## "NOTES" APPLICATION & SERVICE

**DATE**: June 5, 1995

SUBJECT: UPDATE ON EPC-100 AND PROPER INSTALLATION

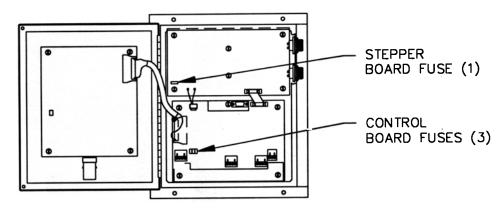
Recent improvements to the 681 051 board include the replacement of all 3 amp fuses by the new 6.3 amp slo-blow type fuses. This new fuse should help to eliminate damage to the board when miswired and still provide protection from short circuits and major miswiring errors of the 24 VDC power circuit. The old fuse part number was 601 460 and was yellow in color. The new fuse is black. It is the same part number as the stepper drive board fuse (601 653) and is shown in the 1-95 edition of the EPC-100 Operating Manual.

Existing installations need **not** upgrade the fuses to the 6.3 amp versions unless grounding problems have been experienced. Always replace all three fuses as a set with the 6.3 amp versions if any of the 3 amp fuses should blow. The drawing above shows the fuse locations.
